MEMORANDUM TO PLANNING COMMISSION

DATE: April 21, 2022
FROM: Russ Holley, Senior Planner
SUBJECT: **Altura Resubmittal**

Project #22-019
Altura
Located at approximately 830 W. 2075 S.

Project Name: Altura
Proponent / Owner: Dan Larsen / Strata Land Holdings LLC
Project Address: ~ 830 West 2075 South
Request: Design Review & Subdivision Permit
Current Zoning: Mixed Residential Medium (MR-20)
Type of Action: Quasi-Judicial
Hearing Date: April 28, 2022 (cont. from 4-14-22)
Submitted By: Russ Holley, Senior Planner

NEW SITE PLAN 4-21-22

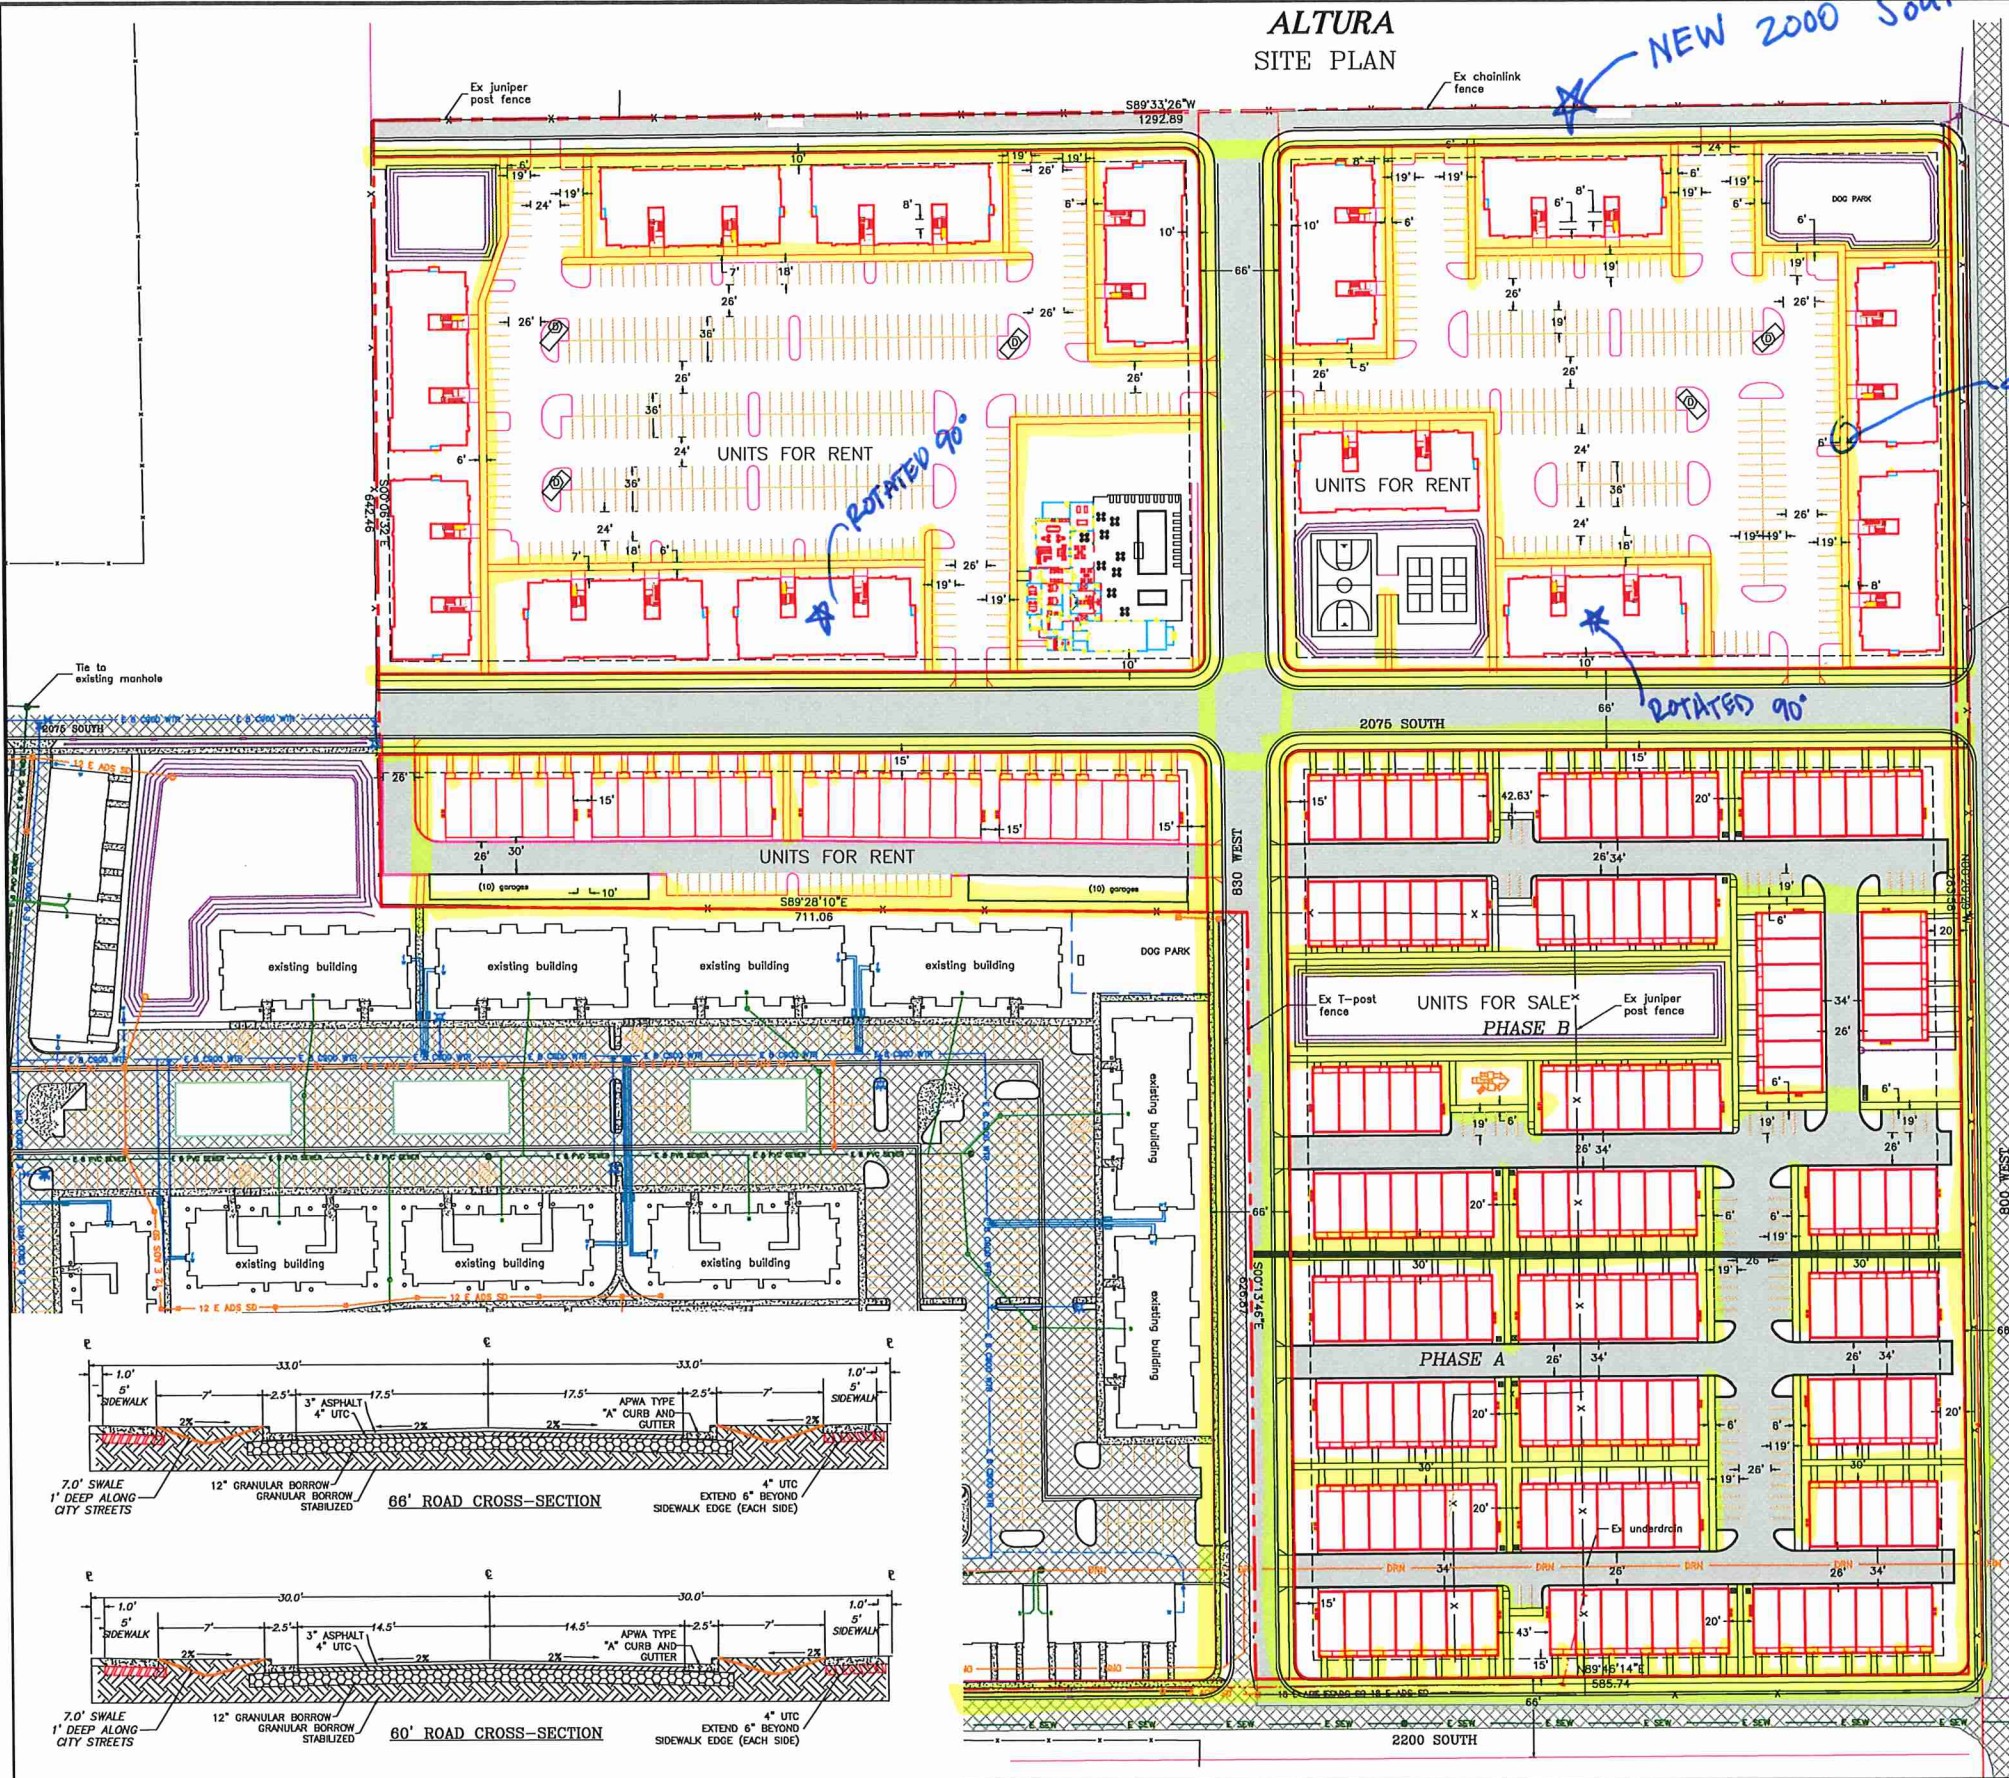
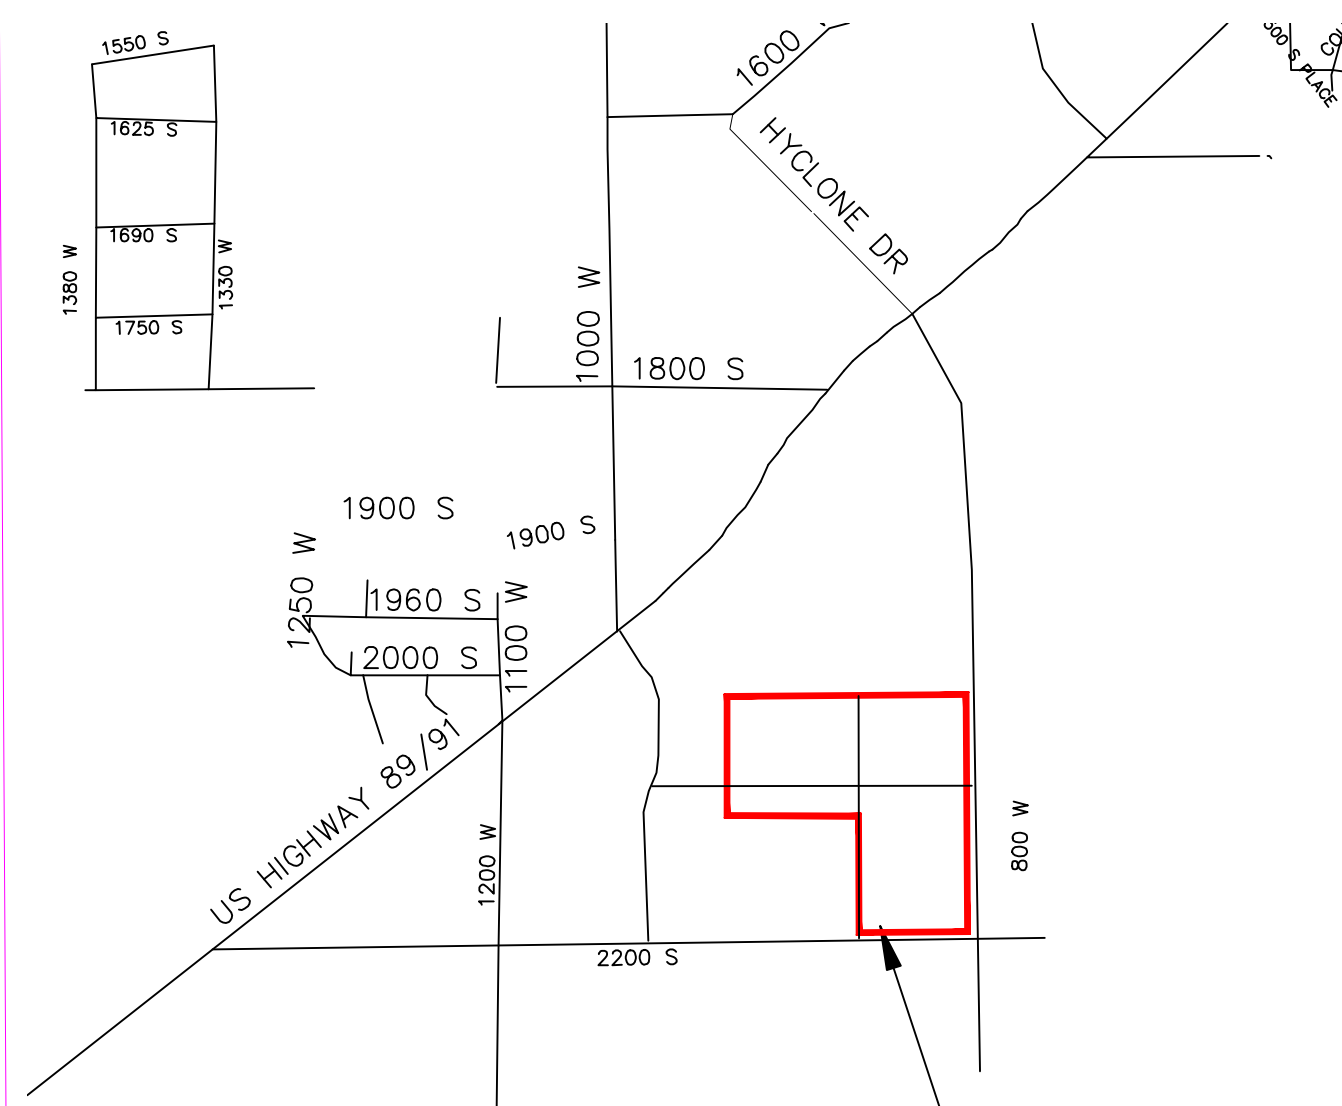
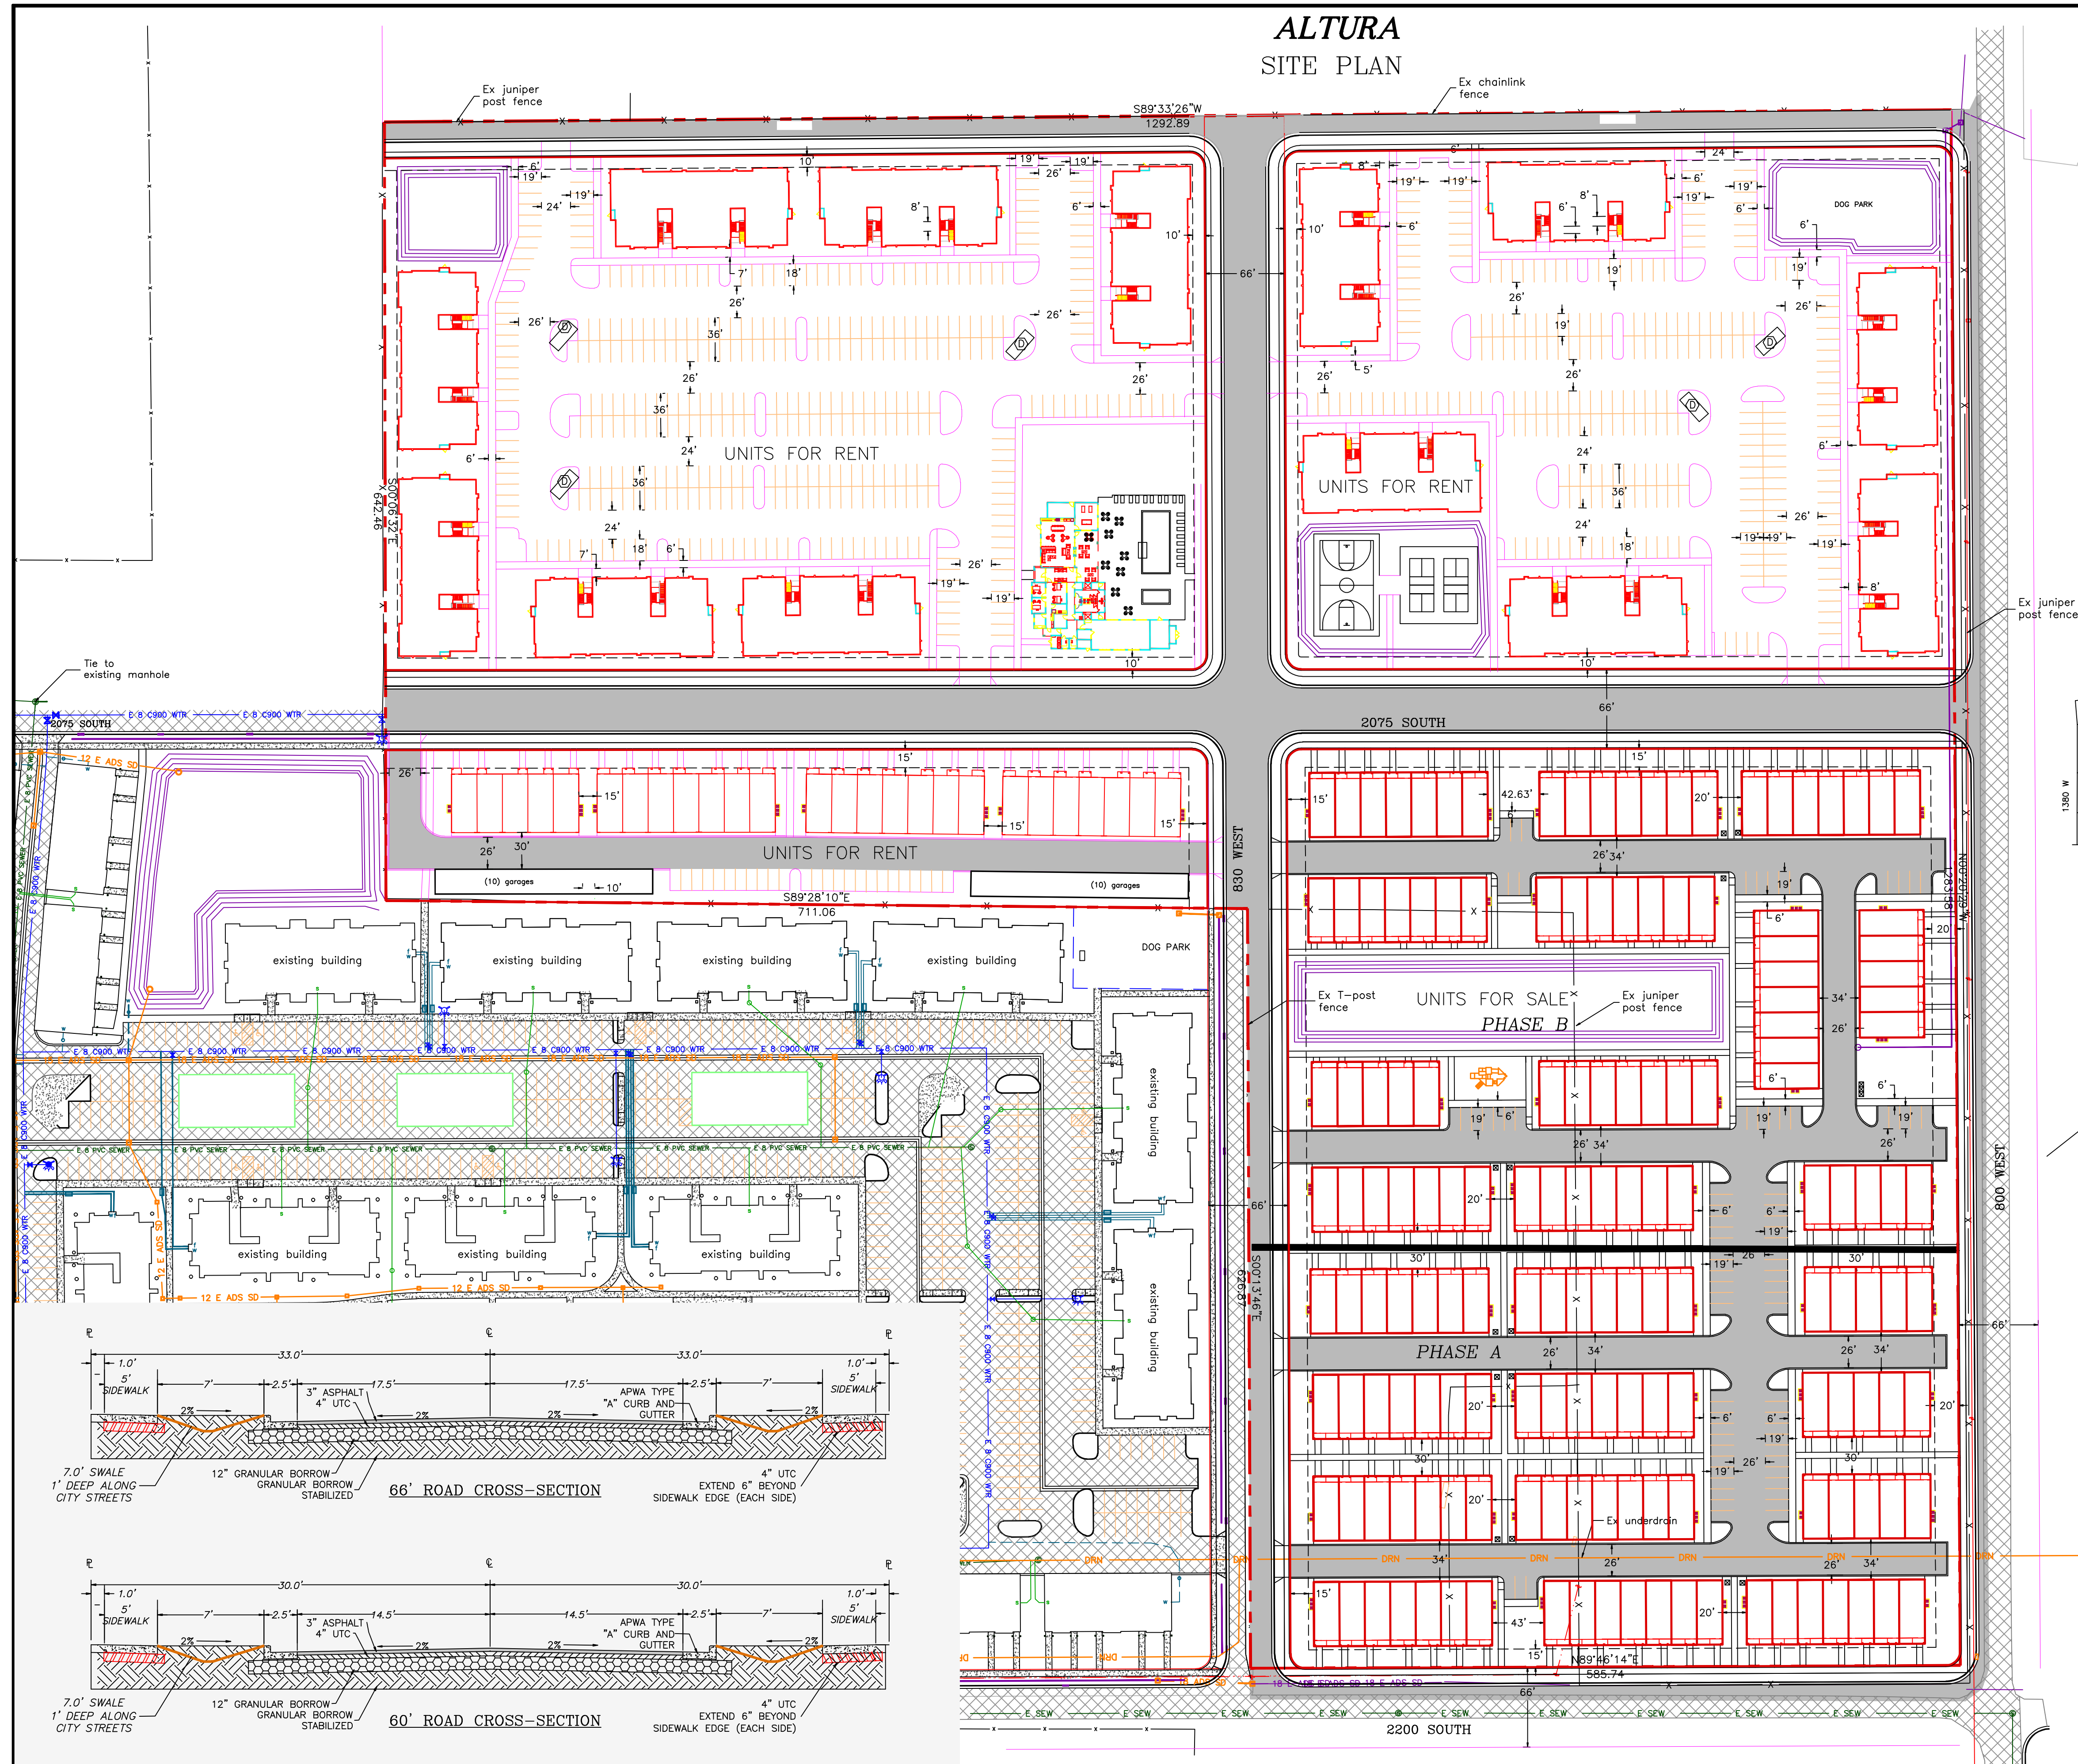
At the April 14, 2022, Planning Commission meeting the applicant for Altura was asked to provide amended plans showing a new 2000 South Street along the north boundary, sidewalk connections from buildings to adjacent streets, rotation of two 24-plex buildings to align with the street and the modifications to rear facades placed adjacent the street. These four items have been addresses in the resubmitted plans.

Logan City's block pattern is not random. Logan City, like the majority of the west, was laid out in the Township and Range pattern. A Township has 36 Sections, with each Section being one square mile in size. The Plat of Zion, the original plat for Logan City, took a Section and divided it into eight square blocks each being 660 square feet. One block equals approximately 10 acres after streets are dedicated. The proposal is approximately 30 acres and based on the standard block size, this project should create three new blocks. As submitted with new site plans, the project meets the LDC requirements.

As proposed, two townhome building are shown 15 feet apart and just shy of the 8-foot (16 feet apart) side setback requirements. As conditioned with side setback compliance, the project meets the setback requirements in the LDC.

LDC 17.30.160 requires that developments provide safe, reasonably direct, and convenient pedestrian access between each building and sidewalks along adjacent streets. The proposed project provides reasonable direct pedestrian circulation for the townhome structures as most have front doors adjacent to the street. The 24-plex buildings show relatively direct sidewalk around each building to reach the adjacent street. AS submitted, the project meets the requirements of the LDC.

The proposal creates 156 individual townhome building lots (for sale units) and three (3) larger lots (for rent units) for the remaining buildings. The preliminary plat fails to show a common parcel enclosing the “for sale” townhomes as there is common area on that block and it is separated by public streets to the other common parcels. As conditioned, the project complies with the LDC.

3. Townhome buildings shall be placed at least 16 feet apart to meet 8-foot side setback requirements.
4. The project shall provide at least 988 parking stalls and bike racks/parking near/inside each building intended for rent.

5. This permit authorizes 494 dwelling units.
6. This permit authorizes 156 townhome subdivision lots, 3 building lots for the other structures and one common area non-building lot around the “for sale” townhomes.
